**The Proposed Rookery South (Resource Recovery Facility)
Order**

Addendum to Flood Risk Assessment dated 4 August 2010

9 May 2011

Drawing Status		INFOMATION	
Date of 1st Issue	12/03/10	Drawing Number	Revision
A3 Scale	1:2000	21780/077/001	C
Drawn by	EJC		
Checked by	PJ

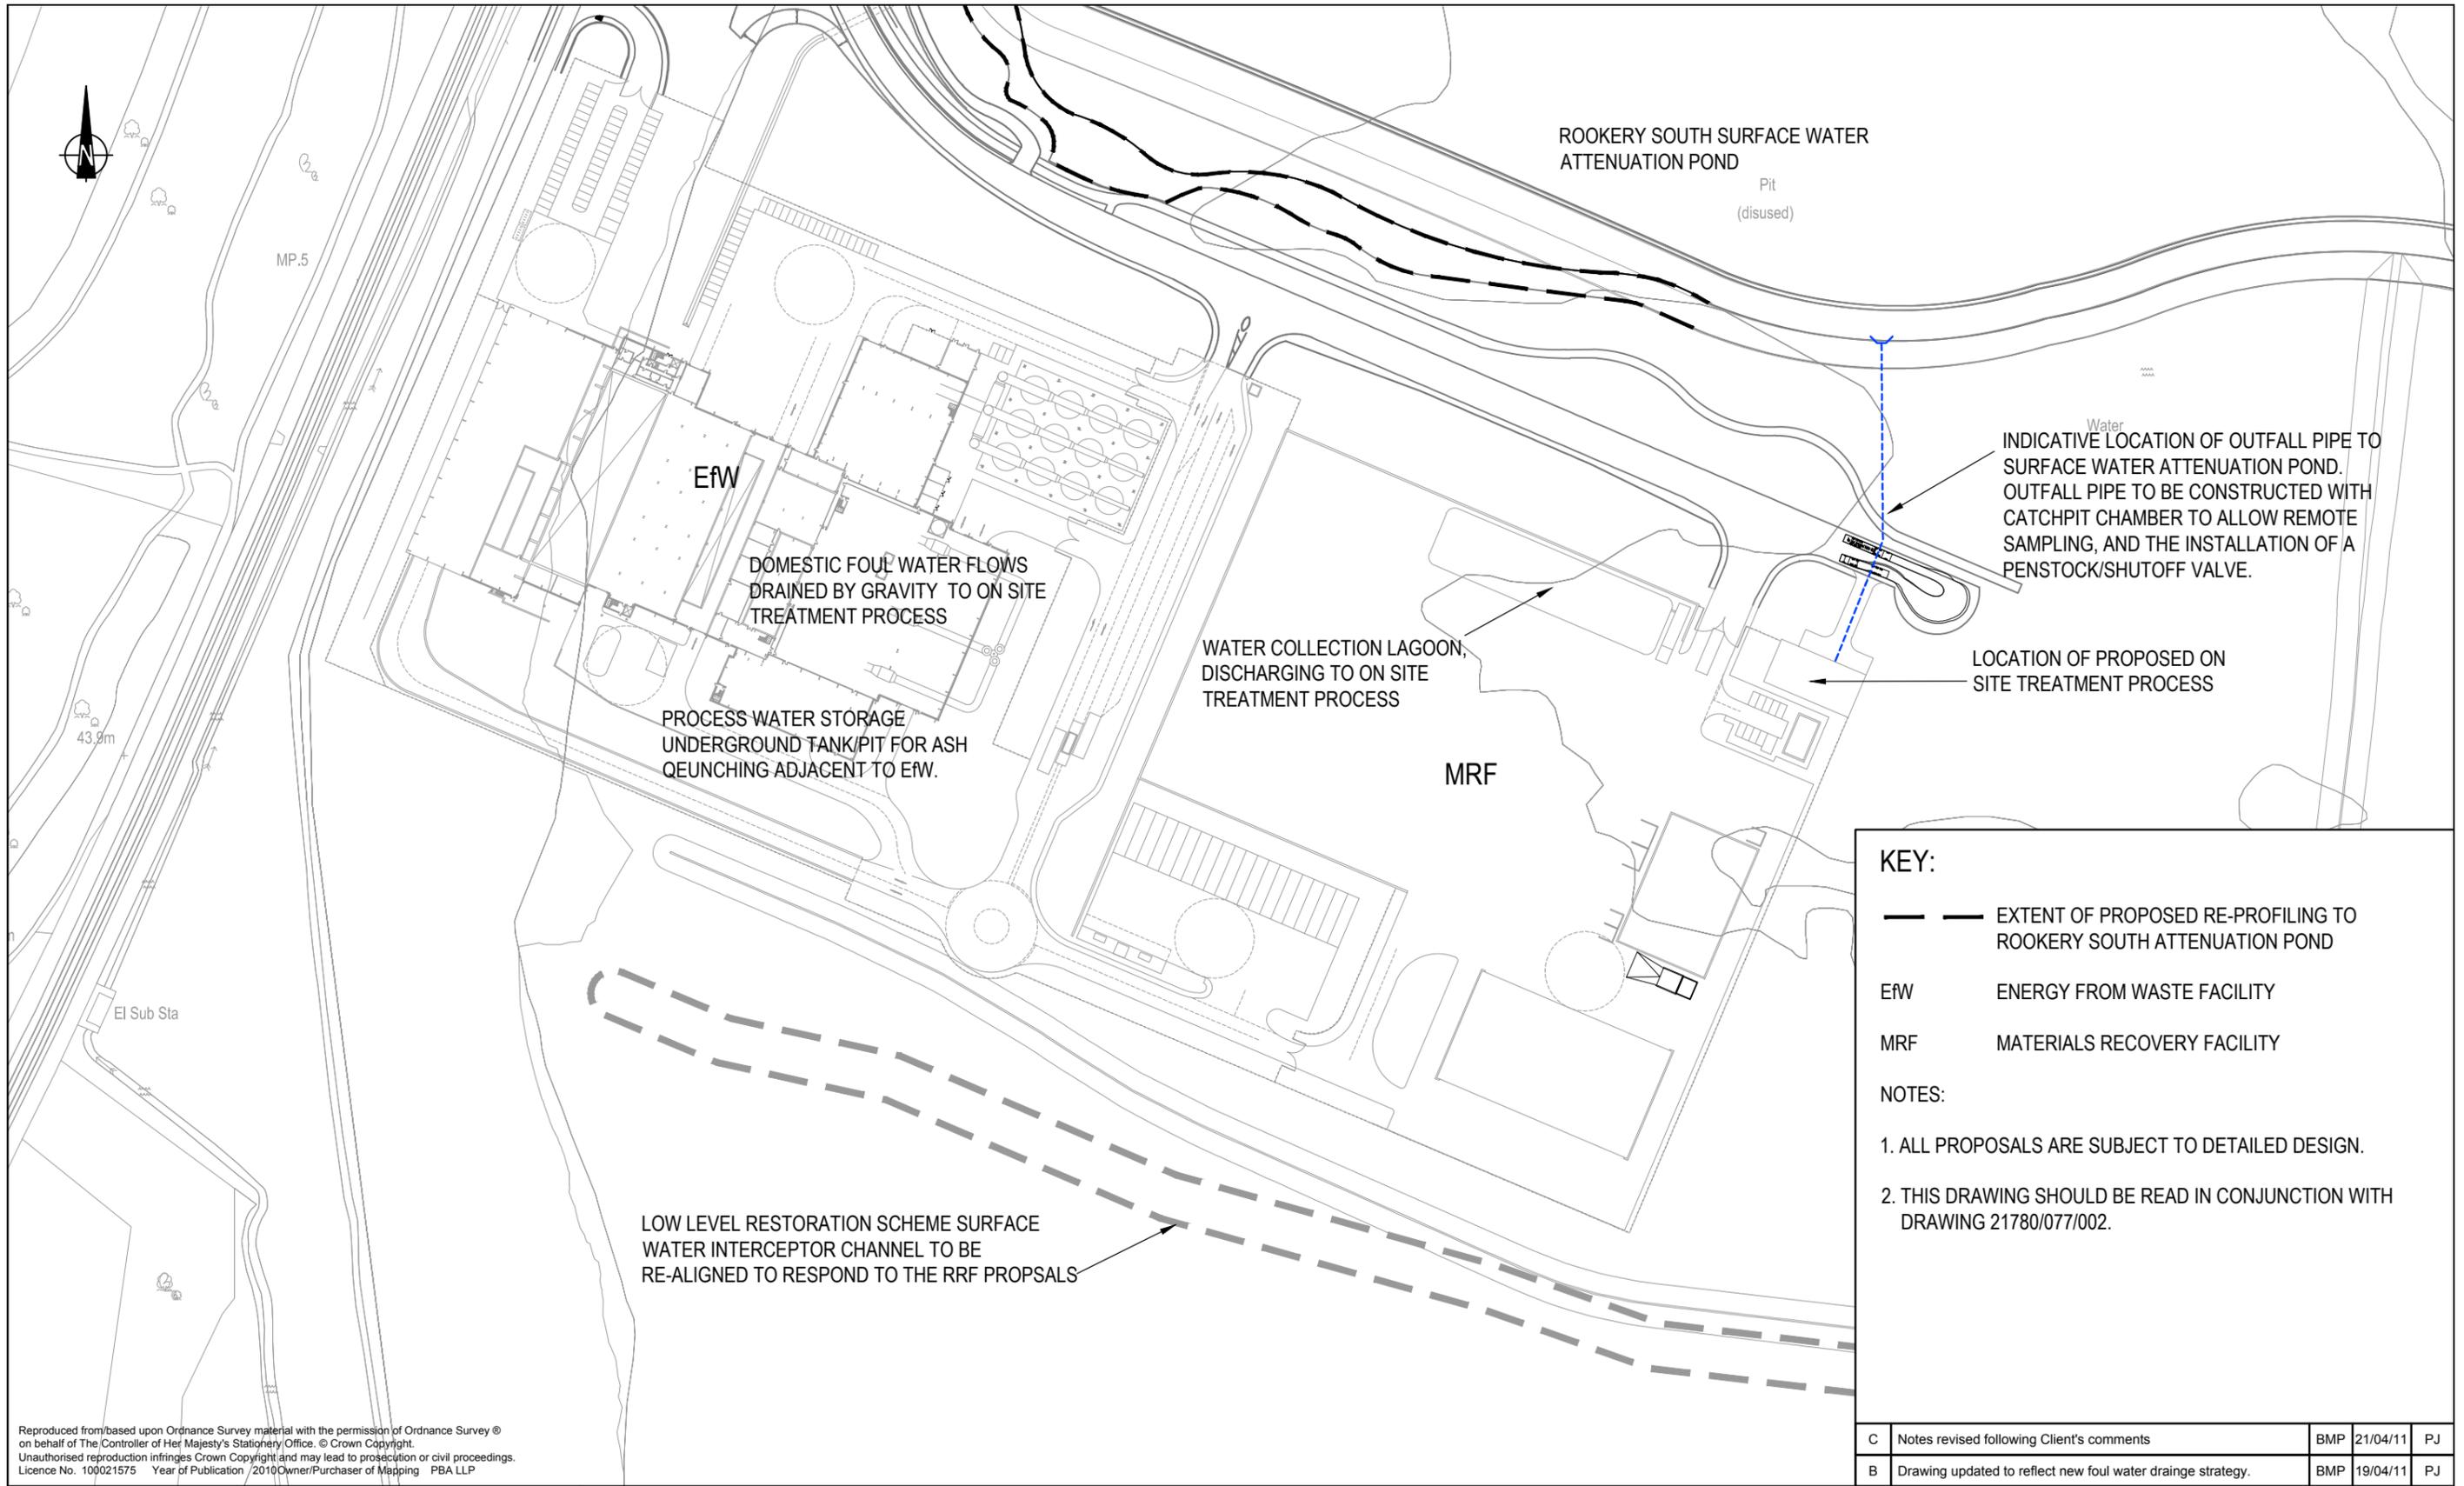
- 3.4. The RRF foul water drainage strategy will now therefore comprise the following:
- i) Domestic foul water flows (toilets, shower rooms, and kitchen facilities etc) will be drained via a private gravity foul water drainage network within the RRF outfalling to a Rotating Biological Contactor (a well established 'package' aerobic biological plant used for treating domestic waste water) for treatment. The domestic foul water flows remain estimated to be approximately 14m³/day, which equates to 0.16l/s.

- ii) Runoff from the MRF water collection lagoon will be drawn down at a maximum rate of 5l/s and treated via a containerised electro-coagulation process with pH correction for general removal of contaminants, sulphates, solids, ammonium etc. The runoff will then be passed through a containerised ultra-filtration / Reverse Osmosis (RO) process for reduction of chlorides.

- iii) The treated effluent from the Rotating Biological Contactor (set out above) will be routed through the containerised electro-coagulation and ultra-filtration / Reverse Osmosis process to further improve the effluent quality.

- iv) Effluent from the two processes set out above will be returned to the EfW for use in the EfW process.
 - v) Any surplus treated effluent at any one time in excess of the EfW process requirements or available storage will be discharged to the Low Level Restoration Scheme surface water attenuation pond located to the north of the RRF, and then pumped as part of the wider LLRS surface water drainage strategy. The rate of any such surplus discharge to the surface water attenuation pond would be at a maximum rate of approximately 5l/s.

- 3.5. The above foul water strategy is presented on Drawings 21780/077/01C and 02D, contained within Appendix A. A summary of the proposed foul water treatment processes and technologies is contained within Appendix B for reference.

Mark	Revision	Drawn	Date	Chkd
C	Notes revised following Client's comments	BMP	21/04/11	PJ
B	Drawing updated to reflect new foul water drainage strategy.	BMP	19/04/11	PJ
A	Drawing updated to respond to latest masterplan.	EJC	24/08/10	PJ

PROPOSED ROOKERY SOUTH RESOURCE RECOVERY FACILITY SCHEMATIC OF THE WATER COLLECTION LAGOON AND FOUL WATER DRAINAGE STRATEGY

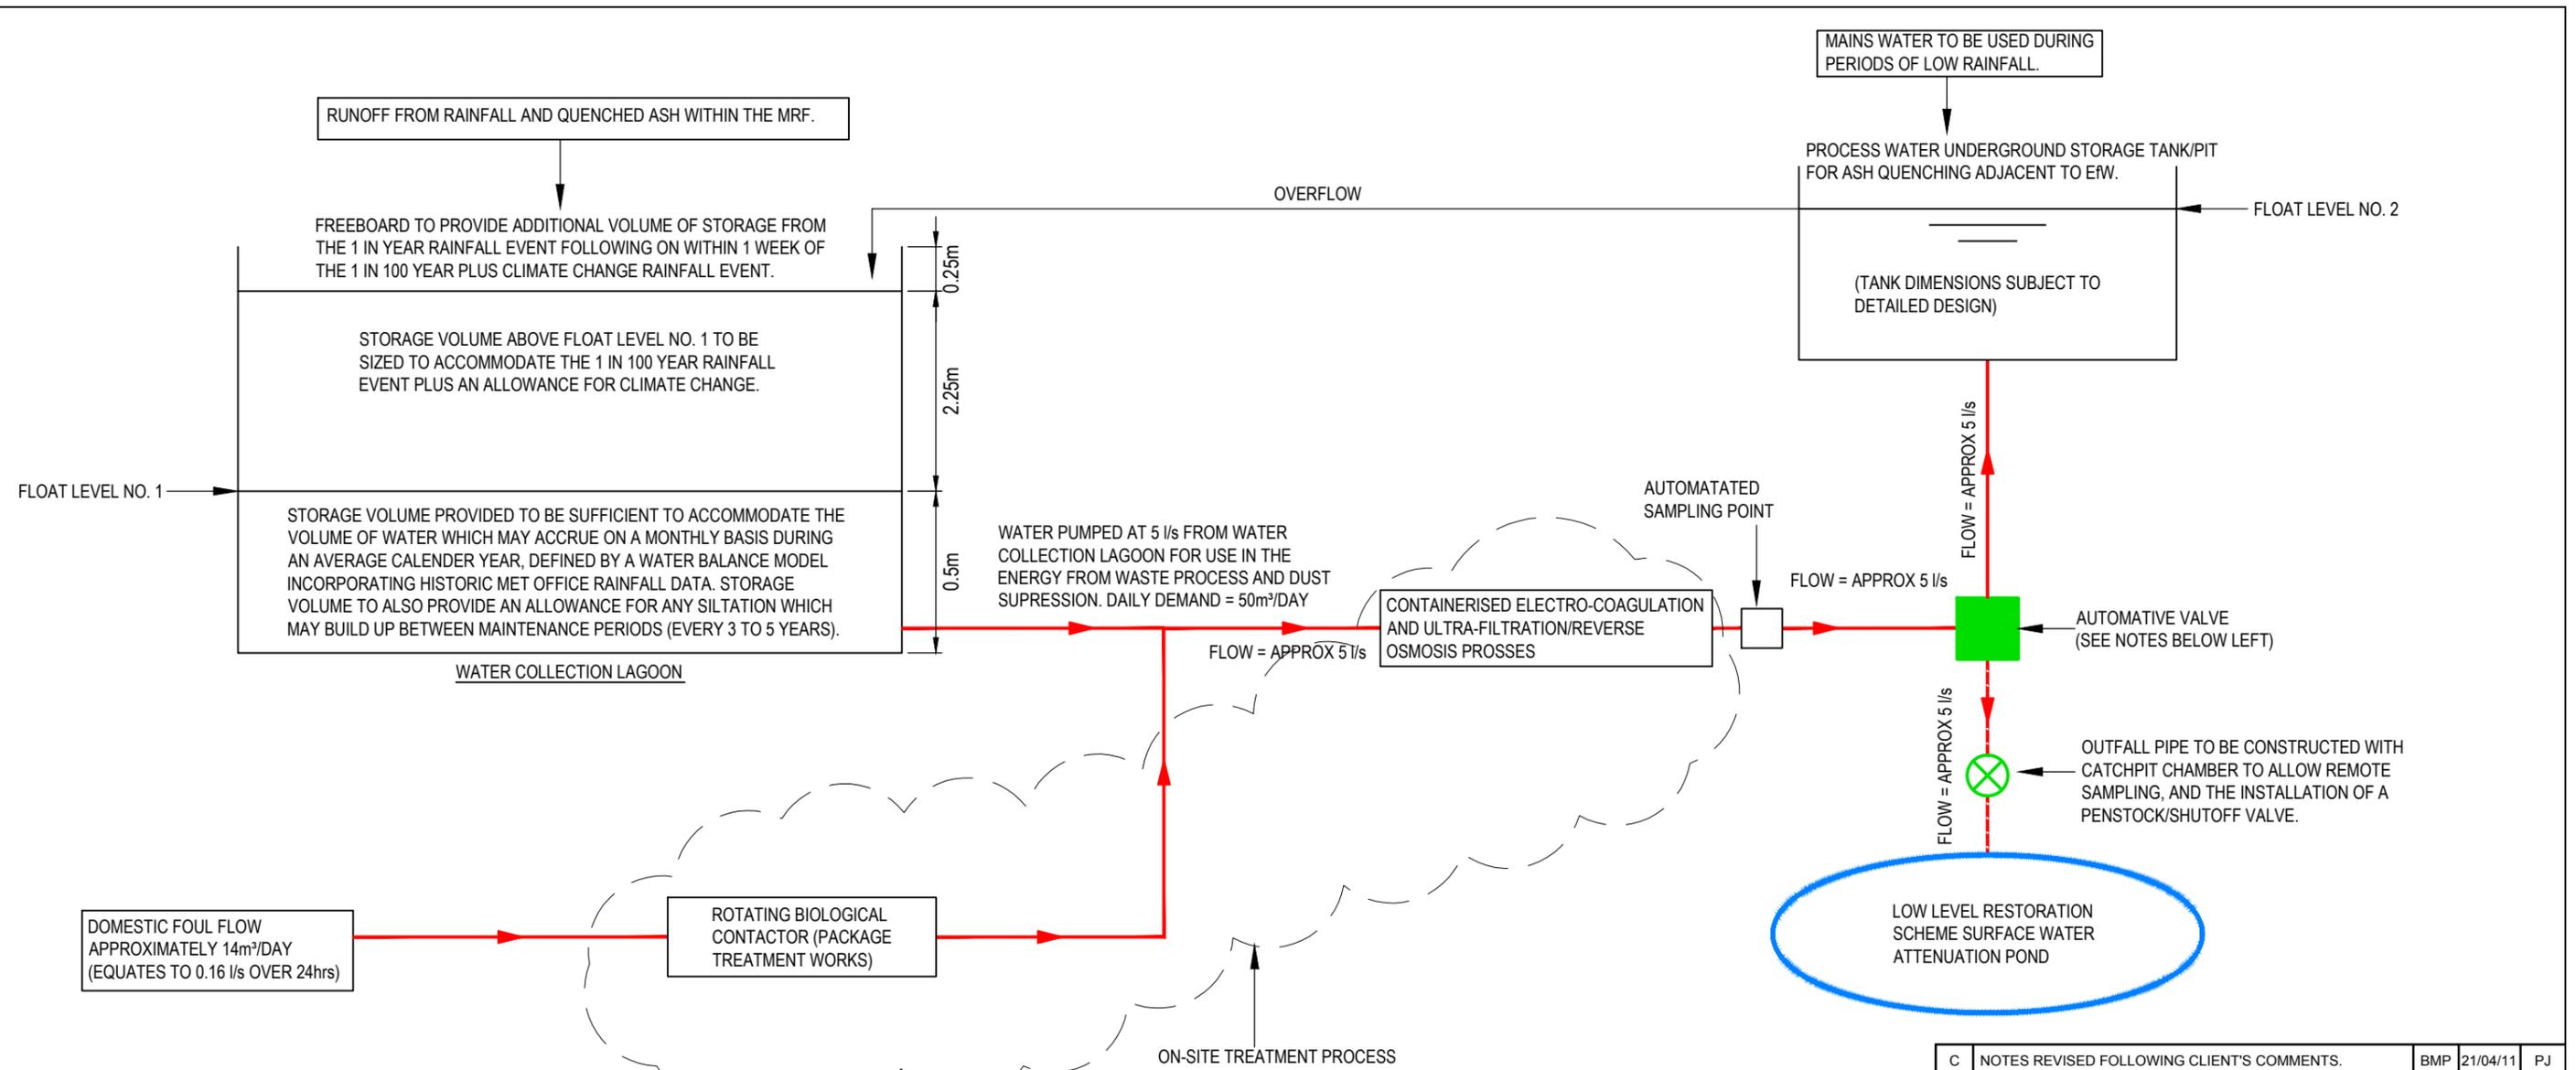
1. AUTOMATIVE VALVE SET TO ALLOW FLOWS TO BE PUMPED TO EW WATER STORAGE TANK UNTIL FULL (AS DETERMINED BY FLOAT LEVEL NO.2)
2. IF THE EW WATER STORAGE TANK IS FULL AND THE WATER LEVEL IN THE WATER COLLECTION LAGOON IS ABOVE FLOAT LEVEL NO. 1, THE AUTOMATIVE VALVE WILL SWITCH TO ALLOW DISCHARGE OF FLOWS TO THE LOW LEVEL RESTORATION SCHEME SURFACE WATER ATTENUATION POND.
3. IF THE EW WATER STORAGE TANK IS FULL AND THE WATER LEVEL IN THE WATER COLLECTION LAGOON IS BELOW FLOAT LEVEL NO. 1, PUMPING FROM THE WATER COLLECTION LAGOON WILL CEASE BUT DOMESTIC FOUL FLOWS WILL CONTINUE TO BE TREATED AND DISCHARGED TO THE LOW LEVEL RESTORATION SCHEME SURFACE WATER ATTENUATION POND.

D	NOTE REVISED TO CONFIRM TREATMENT TECHNOLOGY	BMP	05.05.11	PJ
---	--	-----	----------	----

C	NOTES REVISED FOLLOWING CLIENT'S COMMENTS.	BMP	21/04/11	PJ
B	ADDED NEW FOUL DRAINAGE STRATEGY TO DRAWING	TA	12/04/11	PJ
A	ADDITIONAL NOTATION ADDED TO DRAWING	EJC	24/06/10	CST
Mark	Revision	Drawn	Date	Chkd

FIGURE 1 PROPOSED TREATMENT PROCESS LAYOUT

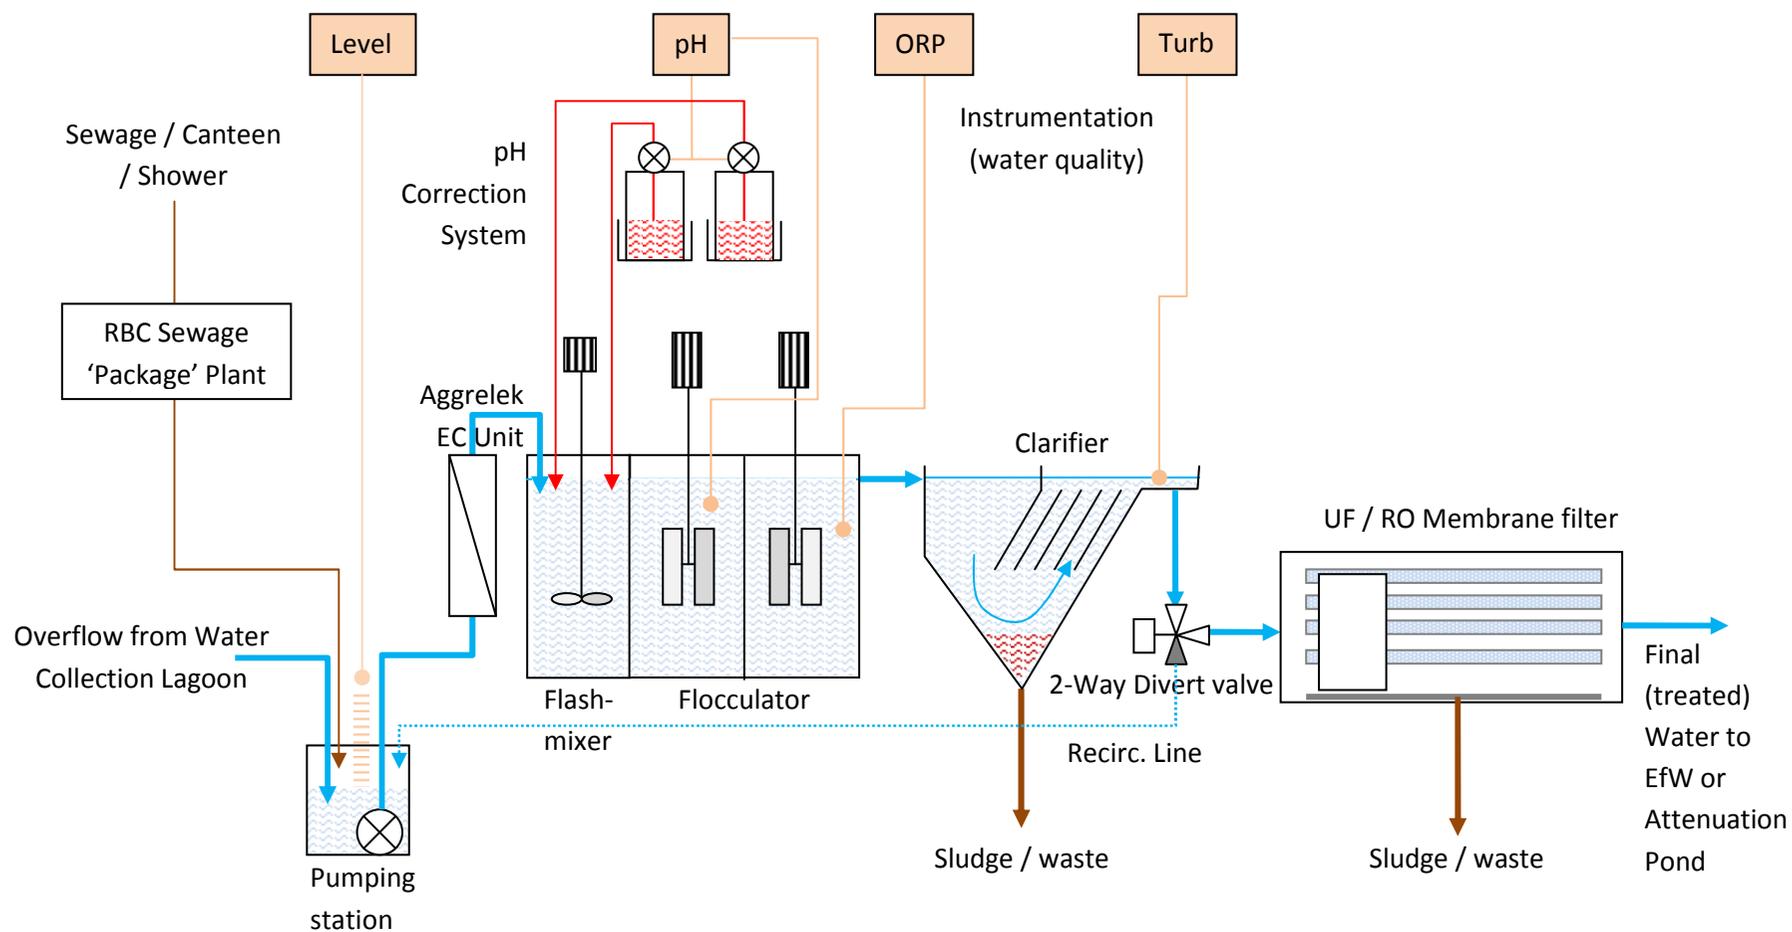
1. A 'package' biological treatment plant (e.g. RBC) for treatment of sewage, canteen facilities and showers ($14 \text{ m}^3\text{d}^{-1}$) (Refer to glossary of terms below);
2. A containerised electro-coagulation process with pH correction for general removal of contaminants, sulphates, solids, ammonium etc (5 ls^{-1}) (Refer to glossary of terms below);
3. A containerised ultra-filtration / Reverse Osmosis (RO) process for reduction of chlorides (5 ls^{-1}) (Refer to glossary of terms below).

Treated sewage and excess water from the Water Collecting Lagoon will discharge directly to a Pumping Station which will feed a front-end Aggrelek electro-coagulation and pH correction followed by Ultra filtration and RO treatment (Figure 1) prior to discharge to Rookery South Surface Water Attenuation Pond.
